From: Brad Harms <bharms@kppcsd.org>
Sent: Friday, October 29, 2021 4:36 PM
To: Monish Sen <monish.sen@pw.cccounty.us>; Mike Gancasz <MGancasz@kppcsd.org>
Cc: John Swann <John.Swann@pw.cccounty.us>; Jerry Fahy <jerry.fahy@pw.cccounty.us>; Kristen Hardeman <kristen.hardeman@pw.cccounty.us>
Subject: RE: Lenox Road

NOT TO SCALE

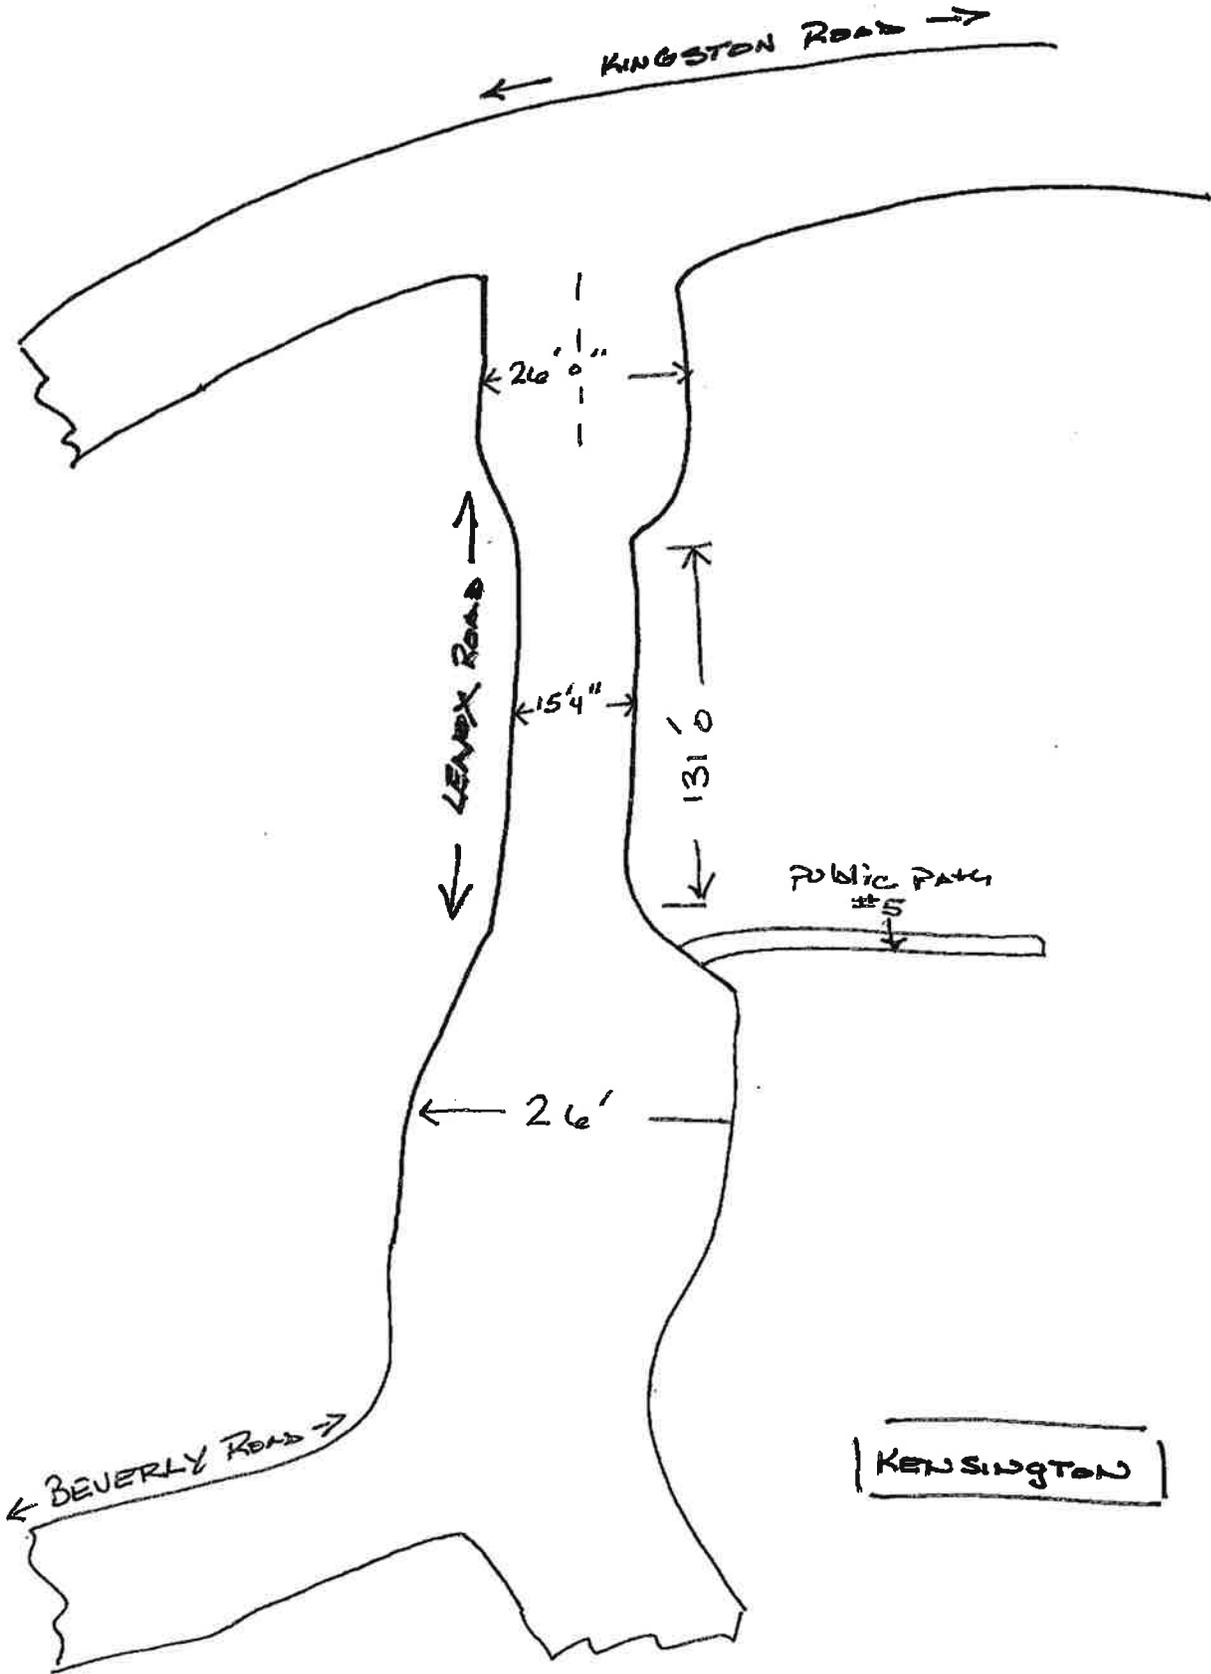
Attached is a diagram (Not to Scale) of the potential “bottleneck” on Lenox Road in the event of a possible mass evacuation. Photo #1 is a view facing southbound and Photo #2 is a view facing northbound.

The diminished roadway length is about 131’ long and is only about 15’4” wide in some areas. The west side of the roadway has a wooden fence that parallel’s the street from a few feet from the edge of the roadway, which essentially makes it difficult or impossible for a vehicle to both park on the side, and allow through traffic on Lenox Road. The roadway is wide and narrows the closer you get to the middle and opens up wider as you approach Kingston Road on the north and Beverly Road on the South. The width of a fire truck can be a minimum of 8’6” and should be considered a factor in deciding the final course of action.

The Kensington Police Department would like the Contra Costa County Public Works Department to either paint red curbs along a greater portion of Lennox Road , towards the middle where there is a diminished width or consider modifications to the roadway in order to widen the roadway if feasible.
